LAUREATE PARK PHASE 6

Owner James L. Zboril Lake Nona Land Co., LLC Applicant Heather Isaacs Lake Nona Land Co., LLC Project Planner Colandra Jones, AICP	Property Location: The subject property is located north of Tavistock Lakes Boulevard, west of Narcoossee Road, and south of Central Florida Greenway (SR 417). (±128.5 acres, District 1). Applicant's Request: Specific Parcel Master Plan (SPMP) approval for the Laureate Park Phase 6 residential development. The project is comprised of 886 residential units with 12 different lot types, including 747 detached single family units and 139 townhome units. The applicant is also proposing to have 151 units of the larger lot types to be gated. In addition to the residential uses, the project also contains areas of open space and a bicycle/trail network.	Staff's Recommendation: Approval of the request, subject to the conditions in this report.
Updated: March 23, 2015

DEVELOPMENT PLAN

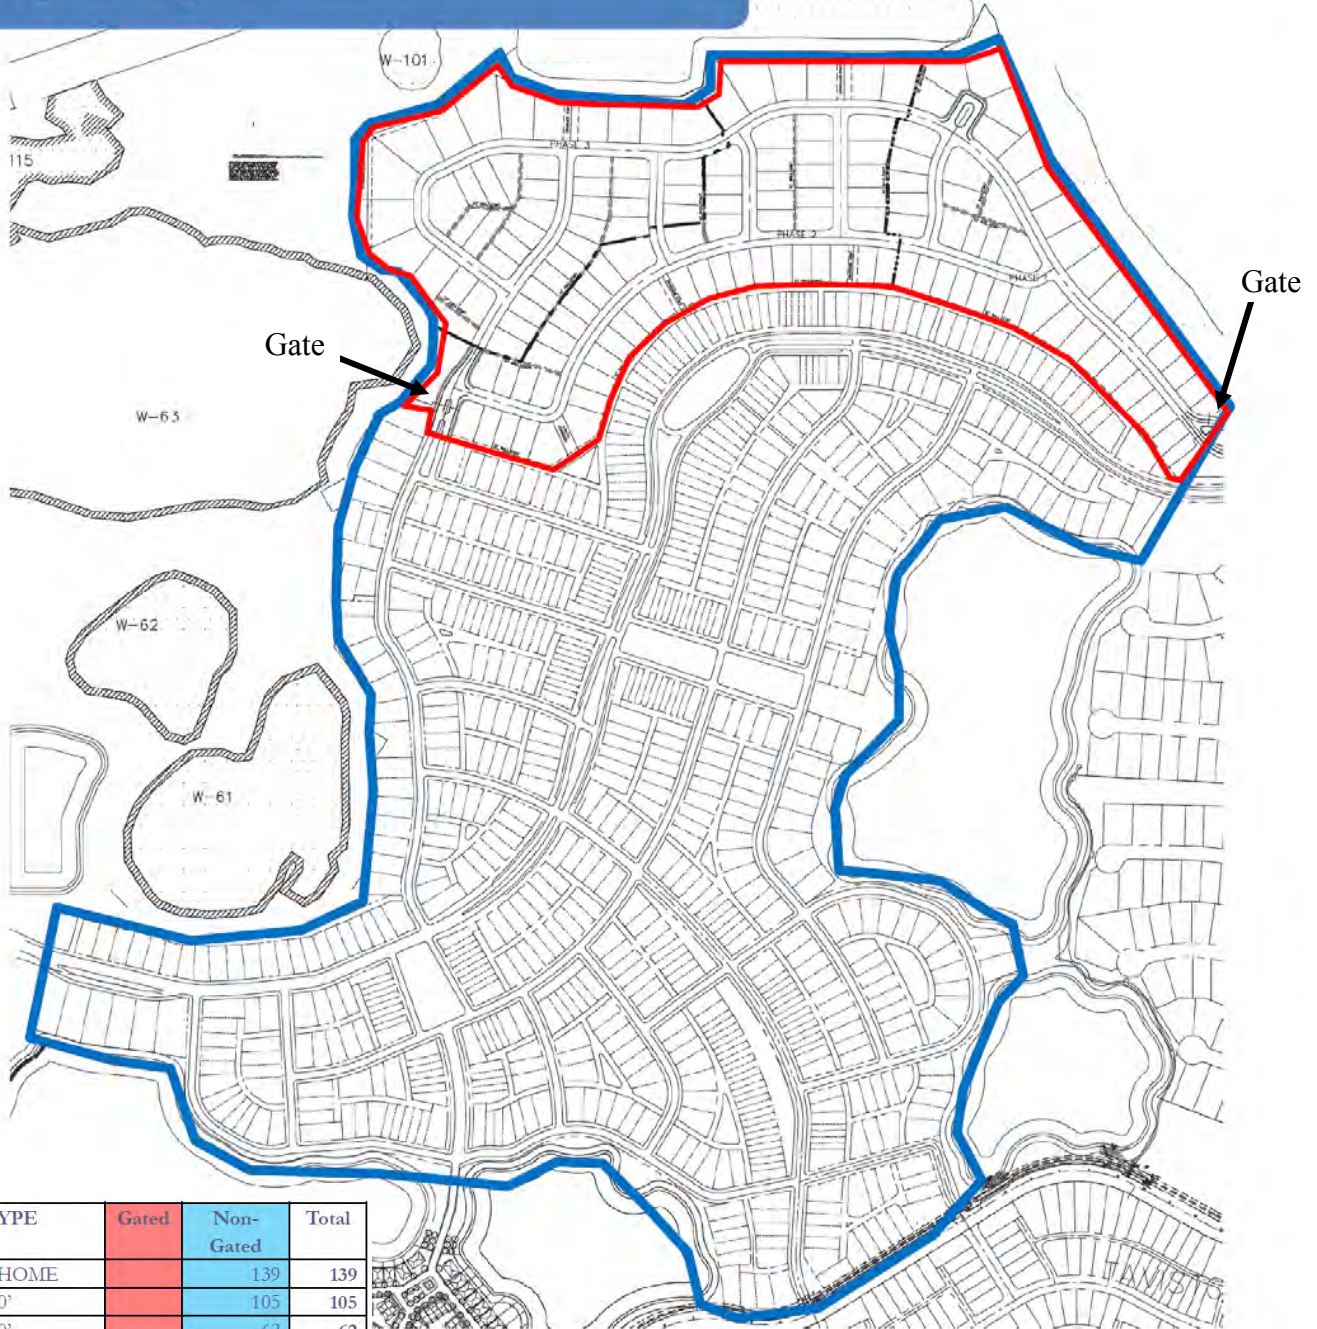
- If the lots south of Wetland #61 is rear loaded, add alley to the roadway map. This can be address at the Preliminary Plat stage.
- Show alley cross section for lot numbers 79, 80, 81, 251, 252, 253, 254, 255, 256, 382, 383, 384. This can be address at the Preliminary Plat stage.
- During the Preliminary Plat review, the City's Solid Waste Division and Fire Department shall review the alley conditions throughout the development to determine if a solid waste truck and/or fire truck can maneuver within the alleys.

TYPE "A" PARKWAY - WITH MEDIAN
100' - MIN ROW

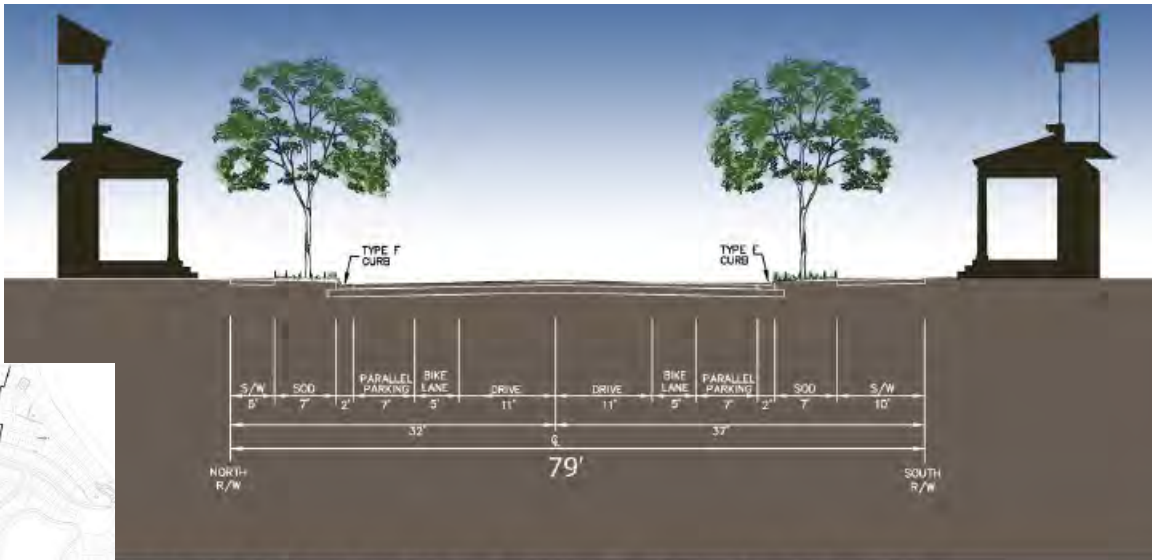
1. Section Type A:
 - Any median curb shall be either FDOT Type A or Type E. Flush curb shall not be used outside of the alleyways.
 - The 10' sidewalk shall be called out as a trail or multi-use path.

TYPE "5" MODIFIED SECTION WITH TRAIL /PARKING
69' ROW

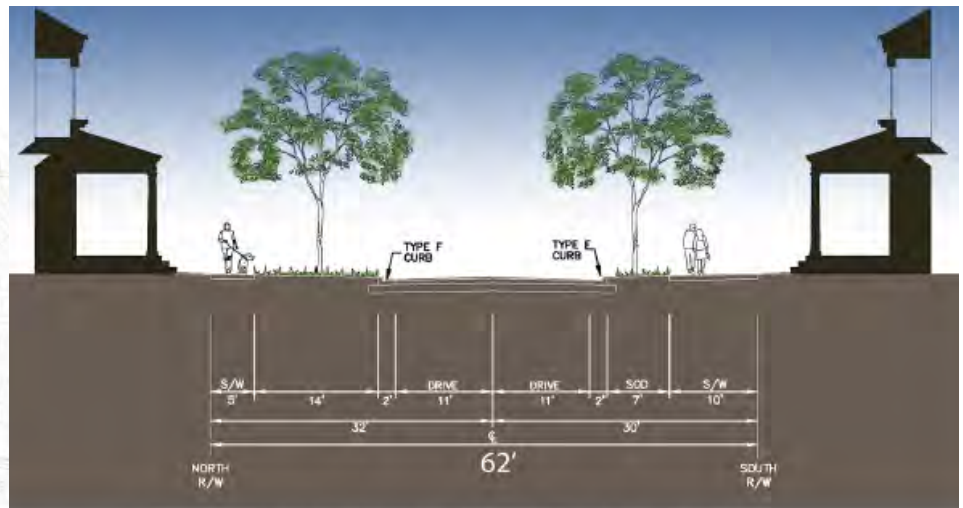
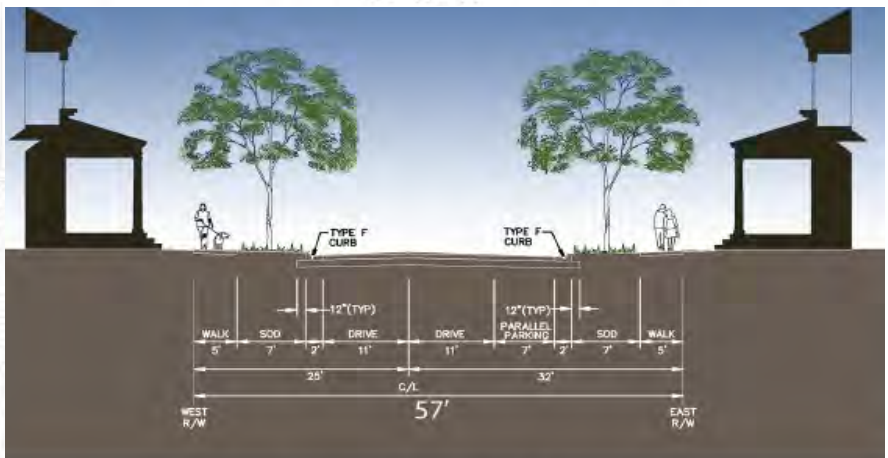
2. Section Type 5 w/Trail and w/o Trail:
 - Both of these sections shall include a 5' wide bike lane in each direction since they tie into Section Type A and are part of the main east-west roadway.

TYPE "B" PARKWAY ONE WAY
48,5' ROW

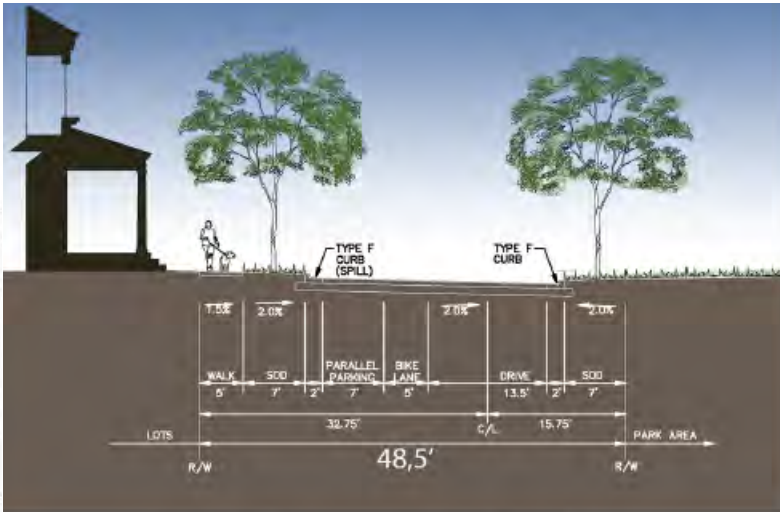
3. Section Type B:
 - The curb along the park shall be FDOT Type F. Flush curbs shall not be used outside of the alleyways.
 - A 5' sidewalk shall be provided on the park side of the road if a continuous sidewalk through the park is not constructed.

TYPE "8" REAR LANE / ALLEY
26' ROW

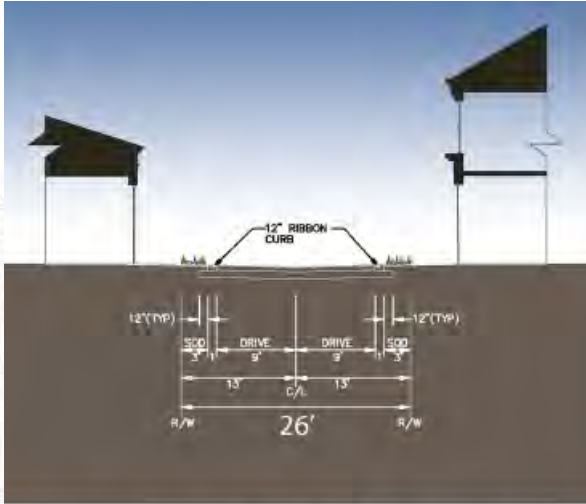
- The 4 short alleys serving the 11 lots facing onto the mews leading to the lakes on the east and west sides of the project shall be shown as Type 8 - 26' alleys.
- The divided Type 6 roadway leading to the west gated entrance to Phase 6 shall be modified to provide safer, direct access to the driveways of the 3 lots on the west side of the roadway OR a plan shall be provide to illustrate how the driveways for these lots will be configured.
